SK#17
02 pages
2-Queries
Date: 06-27-2025

R : HP NAREF, 1250 MARYLAND HOLDINGS 1 LP.
RIPTION : 1250 MARYLAND AVENUE
ESS : 1250 MARYLAND AVENUE, WASHINGTON, DC 20024
IRON FABRICATION SERVICES, INC.

ON :PARTIAL PENTHOUSE ROOF FRAMING PLAN (PHASE-2) (SEQ#20)

1 PARTIAL PENTHOUSE ROOF FRAMING PLAN (PHASE-2) (SEQ#20)

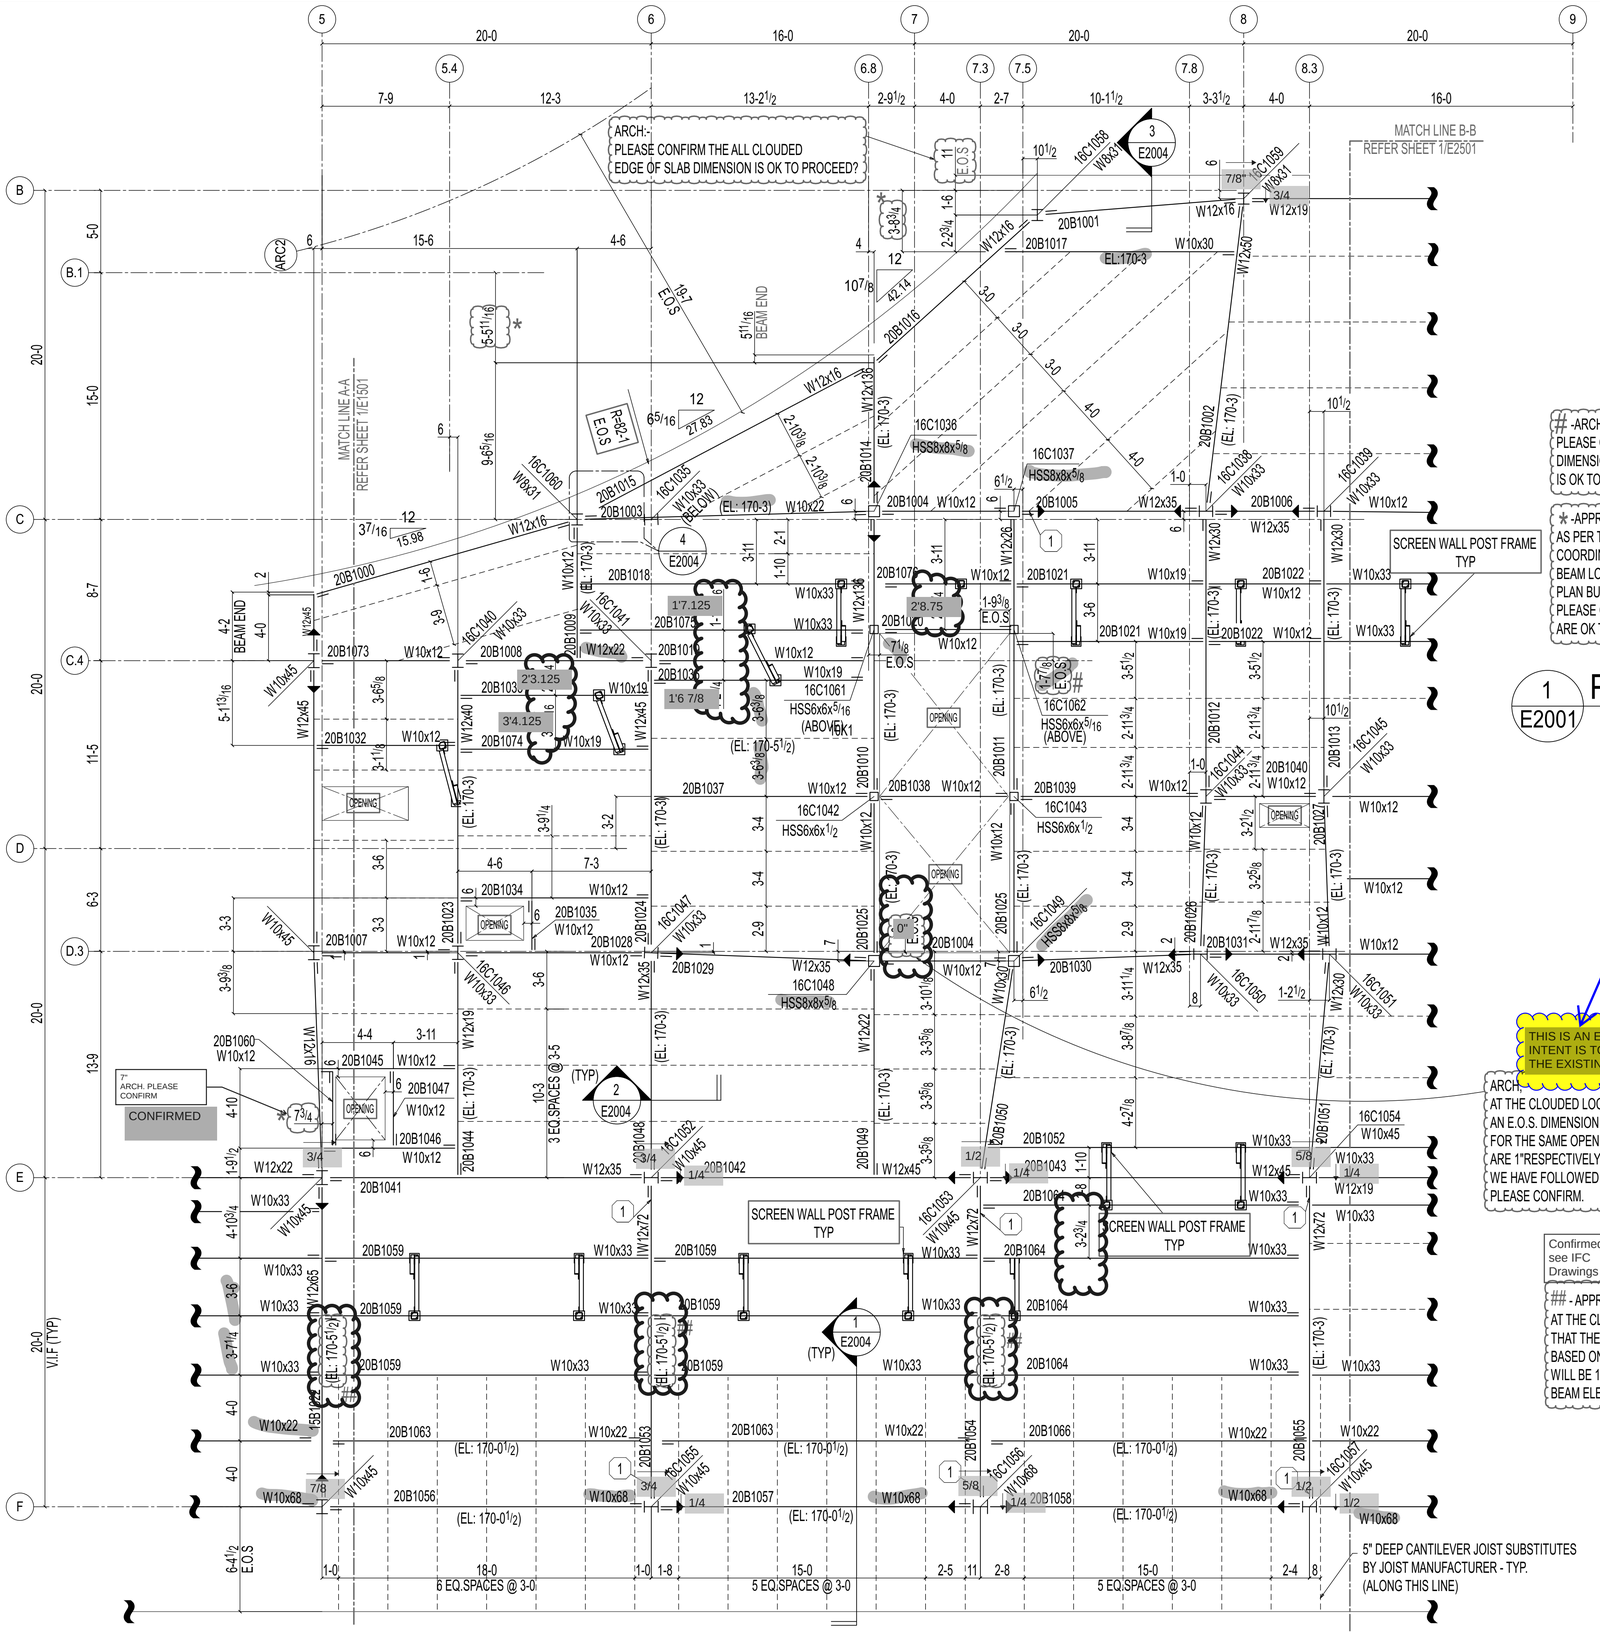
-ARCH:-
PLEASE CONFIRM THE CLOUDED EDGE OF SLAB DIMENSION FOR STAIR AND ELEVATOR OPENING IS OK TO PROCEED?

* -APPROVER,
AS PER THE APPROVER'S RETURNS COMMENT STATED THAT COORDINATE WITH ARCHITECTURAL SLAB EDGE PLANS FOR BEAM LOCATION. WE HAVE REVIEWED THE 2/A058 SLAB EDGE PLAN BUT WERE UNABLE TO LOCATE SOME OF THE BEAM LOCATIONS. PLEASE CONFIRM WHETHER ALL CLOUDED BEAM LOCATIONS ARE OK TO PROCEED.

Q1 Please provide field measurement for existing elevator shaft at this level.

ARCH,
AT THE CLOUDED LOCATION THE APPROVER COMMENTED AN E.O.S. DIMENSION OF 6" AT LEVEL 9 TO LEVEL11. HOWEVER, FOR THE SAME OPENING AT THE ROOF THE E.O.S. DIMENSIONS ARE 1"RESPECTIVELY. TO MAINTAIN A FLUSH OPENING ALIGNMENT, WE HAVE FOLLOWED THE 6" E.O.S. DIMENSION AT LEVEL 9 TO ROOF. PLEASE CONFIRM.

- APPROVER,
AT THE CLOUDED LOCATION, THE APPROVER COMMENTED THAT THE BEAM ELEVATION SHOULD BE 170'-3". HOWEVER, BASED ON THE FRAMING CONDITIONS, THE BEAM ELEVATION WILL BE 170'-5½". PLEASE RECONFIRM THE CORRECT BEAM ELEVATION.

A/E Please Confirm

OK

THIS IS AN EN EXISTING SHAFT OPENING. INTENT IS TO KEEP THE SAME DIMENSIONS AS THE EXISTING. VIF

Confirmed, see IFC Drawings

OK

PARTIAL LEVEL-09 FRAMING PLAN (PHASE-2) (SEQ#17)

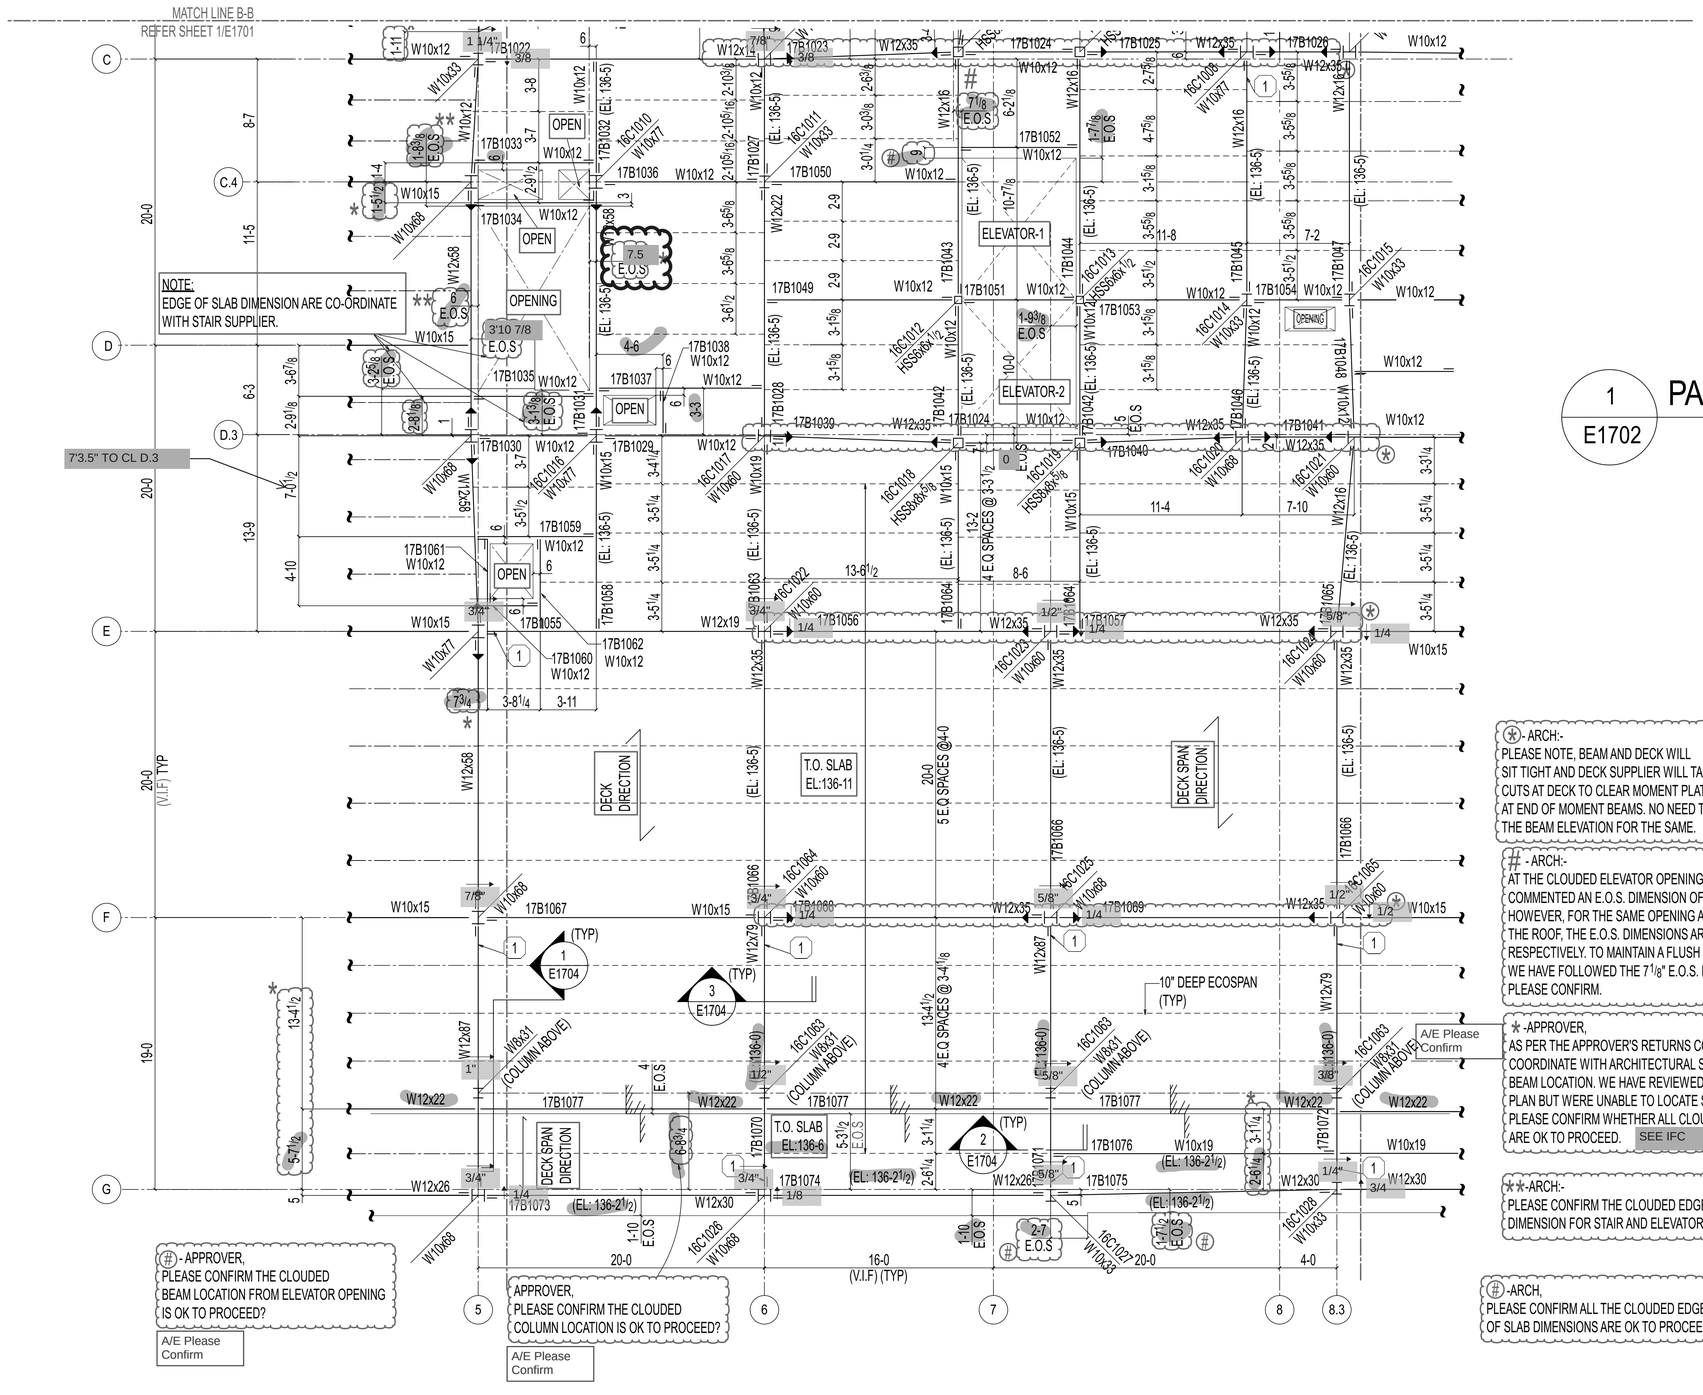
Q2
Please provide Field measurement for the existing elevator shaft opening.

(*) - ARCH:-
PLEASE NOTE, BEAM AND DECK WILL SIT TIGHT AND DECK SUPPLIER WILL TAKE CUTS AT DECK TO CLEAR MOMENT PLATES AT END OF MOMENT BEAMS. NO NEED TO DOWN THE BEAM ELEVATION FOR THE SAME.

(#) - ARCH:-
AT THE CLOUDED ELEVATOR OPENING, THE APPROVER COMMENTED AN E.O.S. DIMENSION OF 3 1/8" AT LEVEL 9. HOWEVER, FOR THE SAME OPENING AT LEVEL 11 AND THE ROOF, THE E.O.S. DIMENSIONS ARE 7 1/8" AND 7", RESPECTIVELY. TO MAINTAIN A FLUSH OPENING ALIGNMENT, WE HAVE FOLLOWED THE 7 1/8" E.O.S. DIMENSION AT LEVEL 9 TO ROOF. PLEASE CONFIRM.

(*) -APPROVER,
AS PER THE APPROVER'S RETURNS COMMENT STATED THAT COORDINATE WITH ARCHITECTURAL SLAB EDGE PLANS FOR BEAM LOCATION. WE HAVE REVIEWED THE 1/A057 SLAB EDGE PLAN BUT WERE UNABLE TO LOCATE SOME OF THE BEAM LOCATIONS. PLEASE CONFIRM WHETHER ALL CLOUDED BEAM LOCATIONS ARE OK TO PROCEED.

(**) -ARCH:-
PLEASE CONFIRM THE CLOUDED EDGE OF SLAB DIMENSION FOR STAIR AND ELEVATOR OPENING ARE OK TO PROCEED?

(#) - APPROVER,
PLEASE CONFIRM THE CLOUDED BEAM LOCATION FROM ELEVATOR OPENING IS OK TO PROCEED?

APPROVER,
PLEASE CONFIRM THE CLOUDED COLUMN LOCATION IS OK TO PROCEED?

(#) -ARCH,
PLEASE CONFIRM ALL THE CLOUDED EDGE OF SLAB DIMENSIONS ARE OK TO PROCEED?

INTENT IS TO MATCH EXISTING ELEVATOR SHAFT OPENING BELOW> VIF
